Subject: Request for Approval of Alternate Procedure
Landfill Sideslope Subbase Design and Horizontal Separation to Property Line
Citrus County Central Landfill Phase 2 Expansion

Subject: Citrus County Central Landfill - Phase 2 Expansion
Permit No.: #21375-004-SC, Citrus County

On behalf of Citrus County, SCS Engineers (SCS) submits the following responses to your request for additional information in a letter dated November 15, 2002. For ease of review, each FDEP comment is reiterated in bold type, followed by our response.

**Liner Stress Analysis - Weight of
Liner, Protective Sand, Refuse, and Equipment Load on Side Slope**

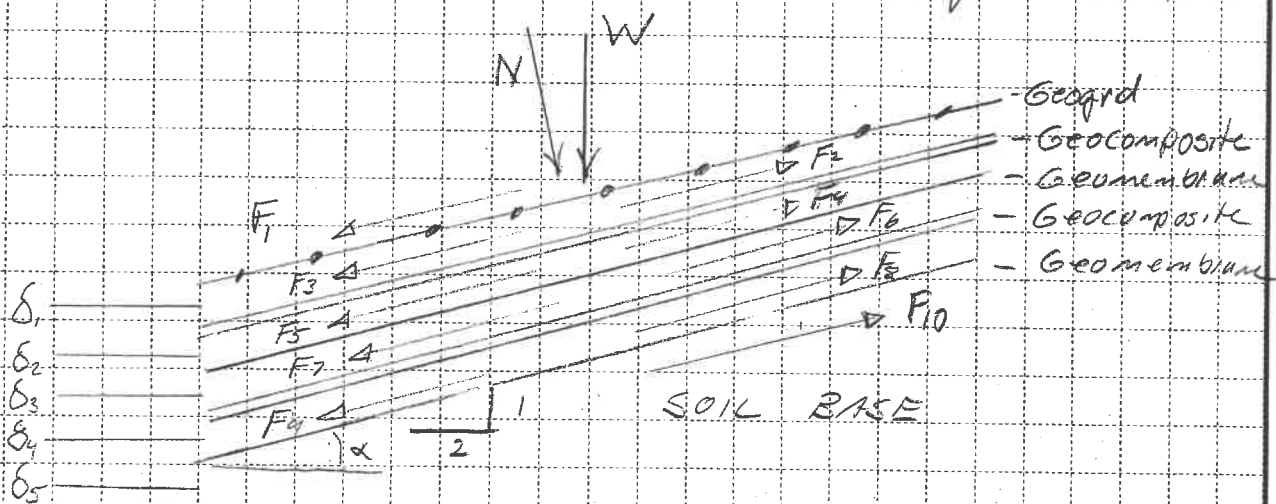
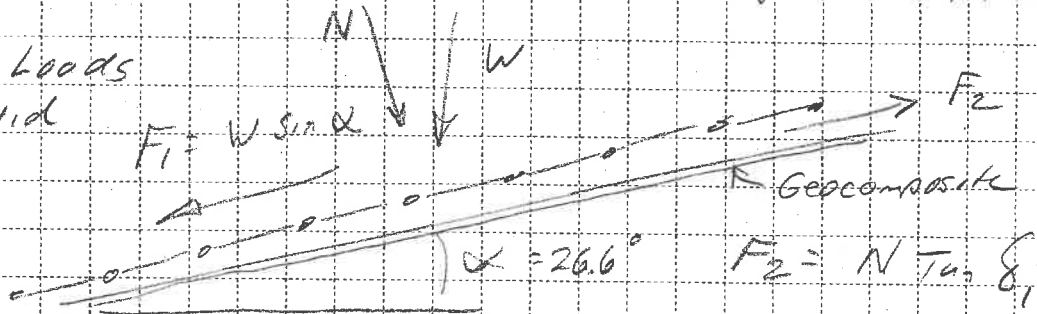
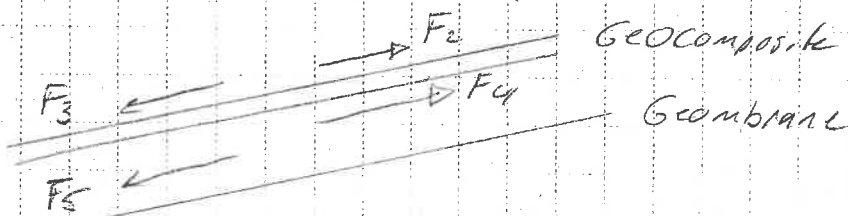
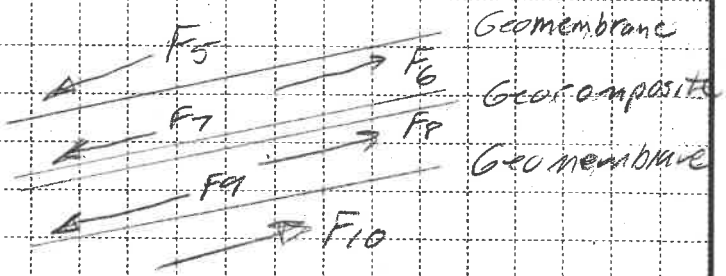
4. **62-701.400(3)(a)1. The rationale for calculating the factor of safety for the internal sideslopes is unclear. Technical documents are requested that support the assumption that the "resistance" to the downslope force (used for calculating the factor of safety) is the sum of the individual resistances provided by each component rather than the resistance of the weakest component (being the geonet). A copy of each of the "technical reference reports on the subject of liner analysis on side slopes" mentioned in Section H.2.a.1 are requested. Each component of the liner system must be able to withstand the stresses imposed by the component's own weight with the weight of the 24-inch sand layer, and any potential down-drag forces from the ongoing compression of the waste, on 2H:IV side slopes with the condition of operating heavy equipment for spreading and compaction. Design calculations must be based on friction angles from published data and confirmed by the actual results from shear box tests for the proposed design.**

7. **62-701.400(3)(d) and (e). 1) Revisions to the project specifications are requested to demonstrate compliance with rules 62—701.400(3) (d)7., 10., and 11. 2) Revisions to Section 3.02D are requested to indicate that the test results shall not be averaged unless specified in SRI CMI3. 3) The coefficient of interface friction angle of 25 degrees as provided in Table 02930-2 is less then the 26.6 degree angle for the proposed side slope, therefore the composite geonet appears to be an unstable component of the liner system. Revision to Table 02930-2 to provide the minimum design interface friction angle, and related calculations for its factor of safety, are requested.**

Response: Please see the enclosed calculations for liner system stress. We have included the use of a geogrid on the 2:1 sideslopes to add an additional factor of safety. The resulting calculations show that no stress is applied to any of the geosynthetic liner system materials. The geogrid specified can withstand the downward force calculated using methods prescribed by Koerner plus the addition of the landfill compactor and maintain at least a 1.5 FS with only 5-percent strain on the material. A portion of the downward force is transferred to the bottom interface due to frictional forces within the liner system layers. The friction angles of the interface between the geogrid and the geocomposite, geocomposite and textured HDPE 60-mil geomembrane, and the textured geomembrane and the bottom soils will be measured with the actual materials to be used on the project. The resulting values will be compared to the values used in these calculations and the factor of safety will be verified.

Response: Please see the enclosed revised specifications for geomembrane, geogrid, and geocomposite products that incorporate the requirements of Rule 62-701.400(3)(d) 7., 10., and 11., FAC. Please note that the angle of the slope and the friction angle of the materials are related only by the fact that the steeper the angle the lower the normal

be. The fact that the slope angle is steeper than a given friction angle does not mean there will necessarily be a failure or stress applied to a material. The entire calculation must be evaluated to make this determination.

$\sigma = F_1 - F_2 = 5891 - 2501 = 3,390 \text{ lb/ft}$

$FS = \frac{5140}{3390} = 1.52 \text{ OK}$

$F_4 > F_3$ No tension F_2 gets transmitted to the next layer = F_5

Because the Friction-Resistance is Greater than the downward Force There is no stress on the material and the downward load is transferred to the next layer

$$F_{10} > F_9 \quad \frac{3597}{2501} = 1.44 \text{ FS}$$

No stress on bottom Liner OK
